NOTIFICATION NO. 1600-2015-0100-R1 – PROJECT INSPECTION REPORT

Subject: Engineering-Geologic Review; Existing Agricultural Pond, AP #208-241-017
Timberline Ranch Estates, Unit P-134, County Line Rd., Mad River, California

Outlet of Rock Ford – Crossing #1. Photo date: 7-16-2019

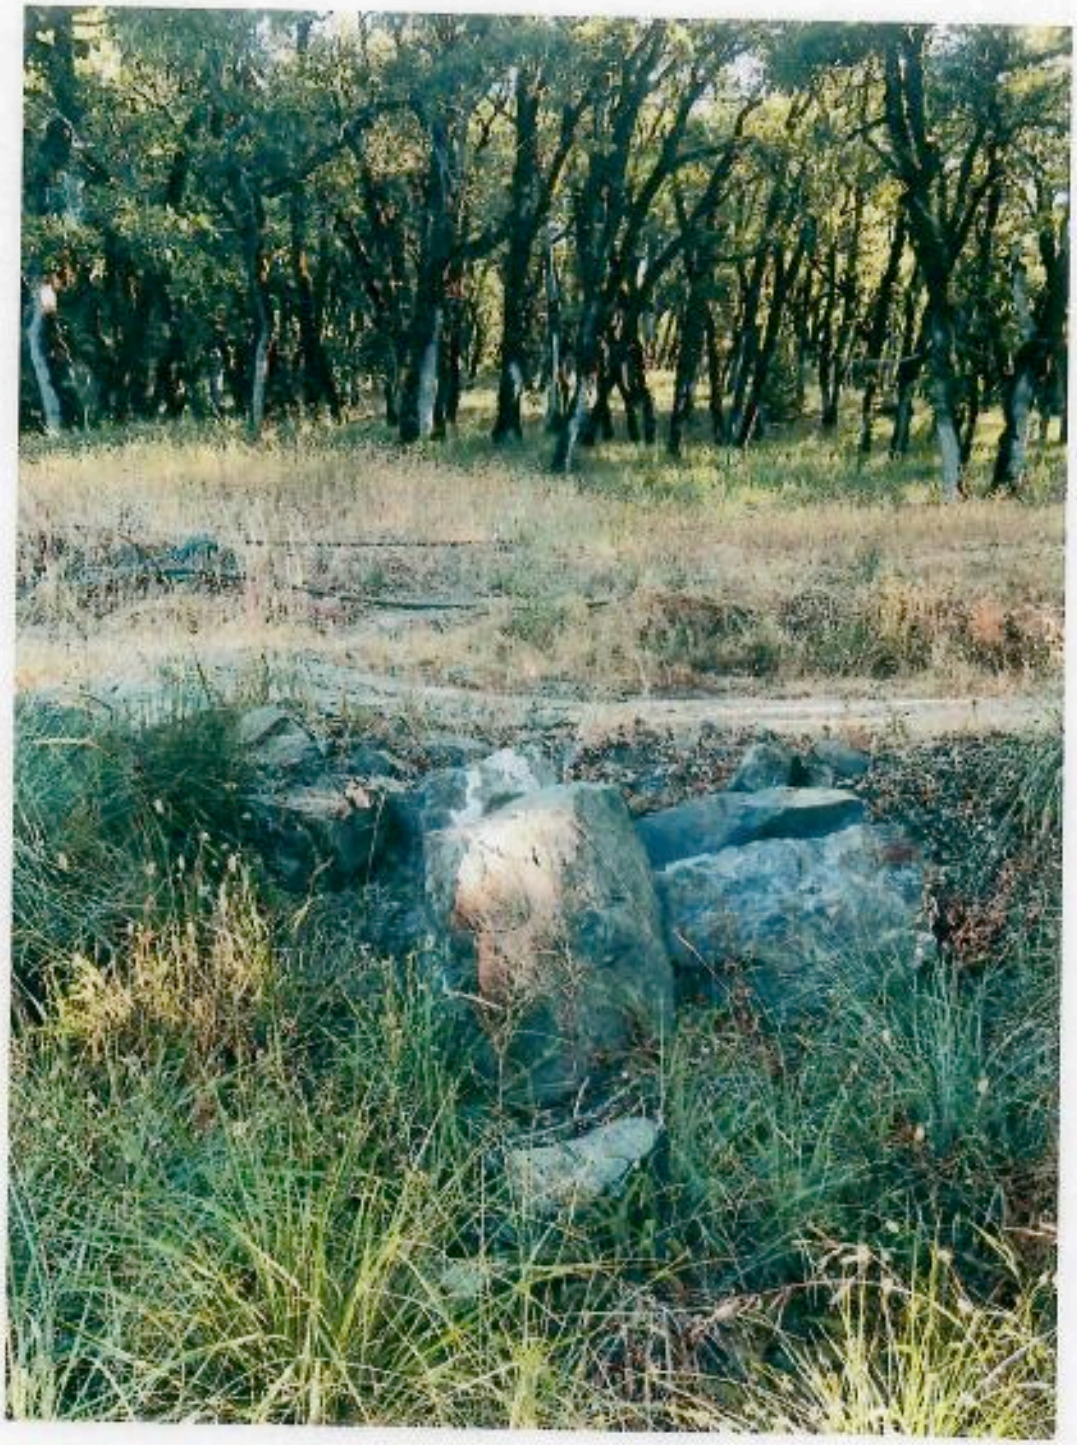
Crossing #1: The rocked ford was installed by the former landowner/Applicant per the specifications stated in the notification and agreement. See attached photographs. TRC recommends maintenance in the form of rocking the approaches to provide a stable operating surface. TRC will be preparing the Site Management Plan and this shall be a recommendation.

Outlet of Rock Ford – Crossing #1. Note pulverized rock and dust, which shall be addressed by adding more surface rock to the approaches. Photo date: 7-16-2019

Rock-lined V-ditch-Pond Spillway. Photo date: 7-16-2019

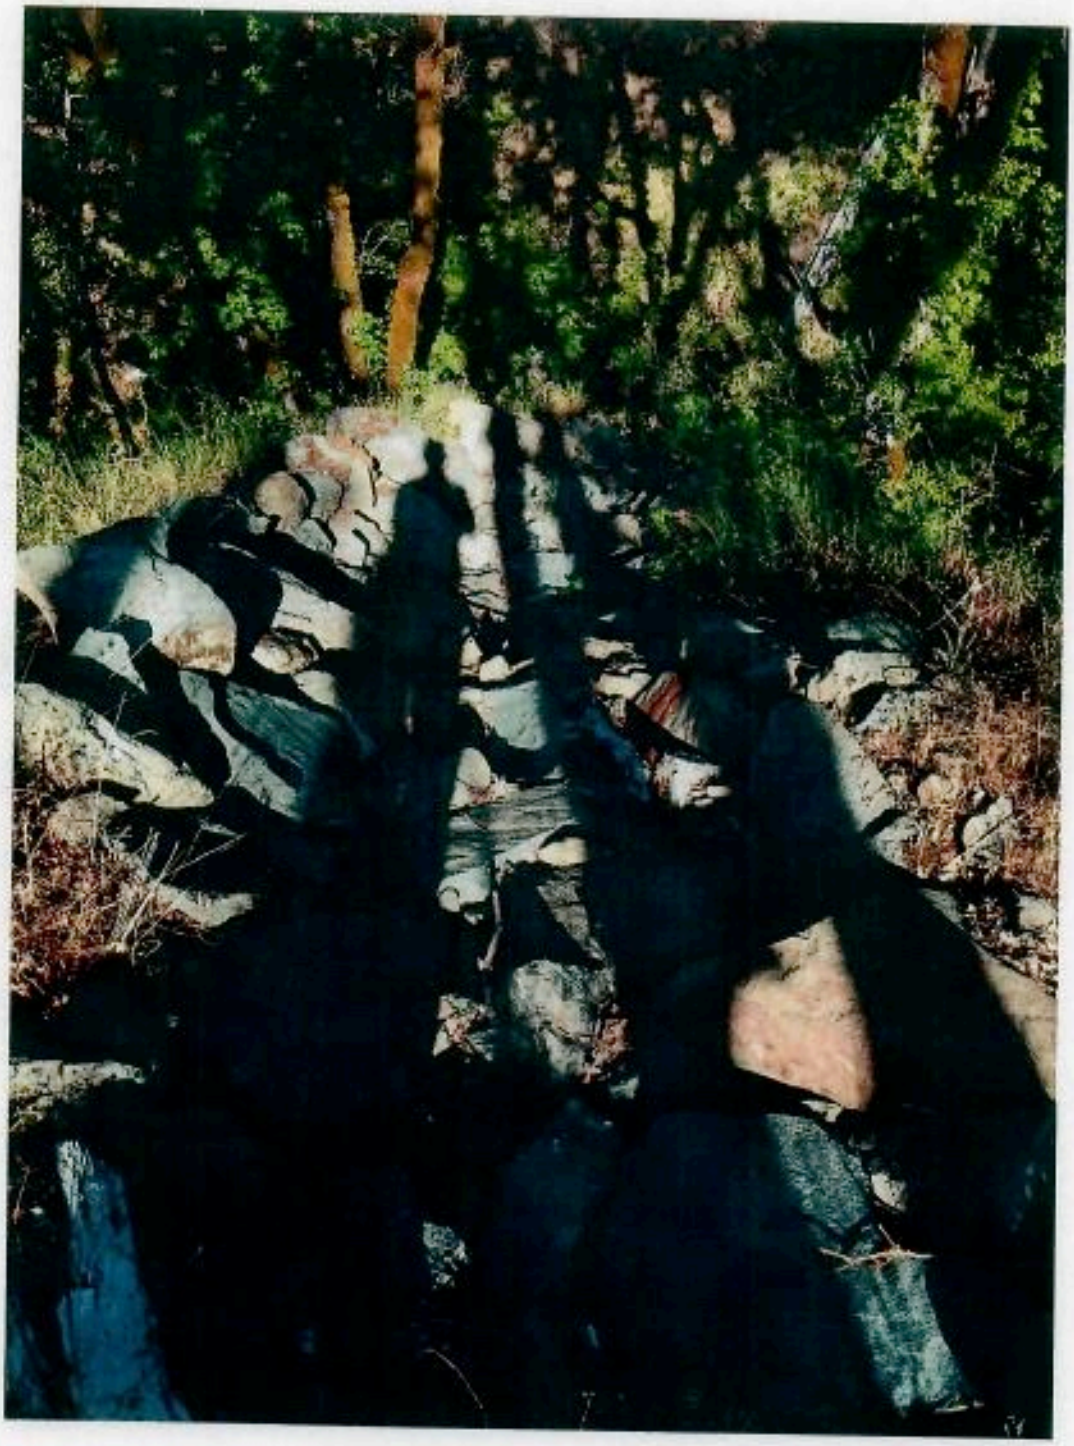
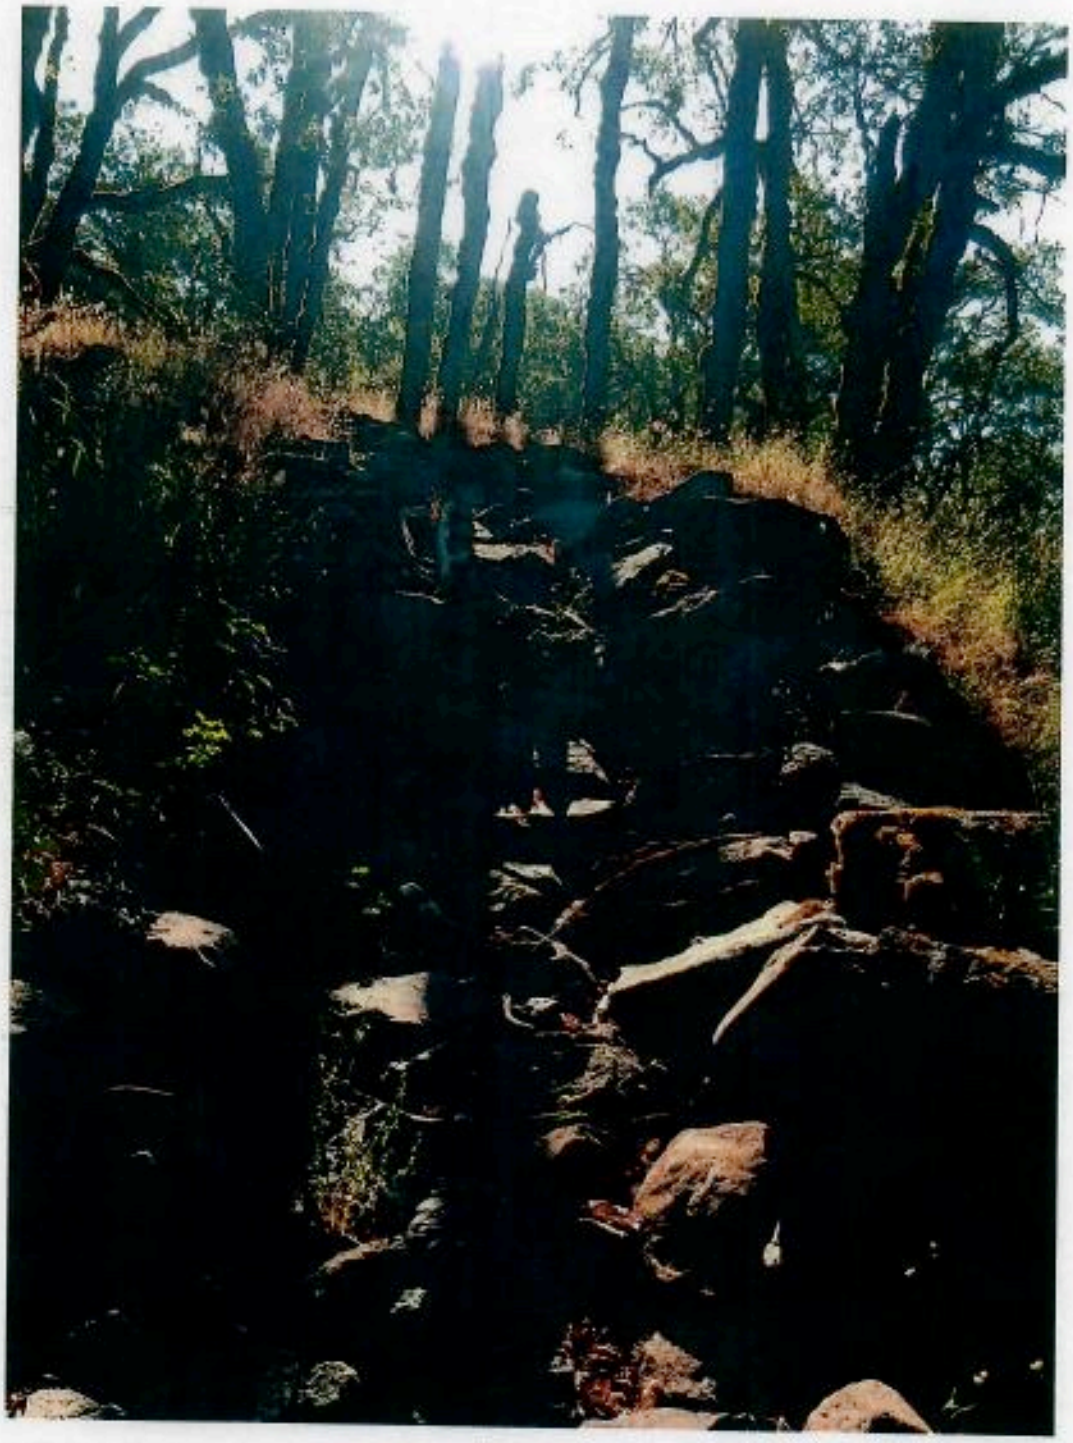
Pond Inspection: See attached Engineering-Geologic Review. All of the CEG's recommendations have been implemented by the former landowner/Applicant as follows: (1) Freeboard was increased to 2-feet; (2) Pond spillway was reconstructed with 1/8-1/16-ton boulders over geotextile; (3) Pond lined with Bentonite, and (4) Erosion control was applied post reconstruction. See attached photographs.
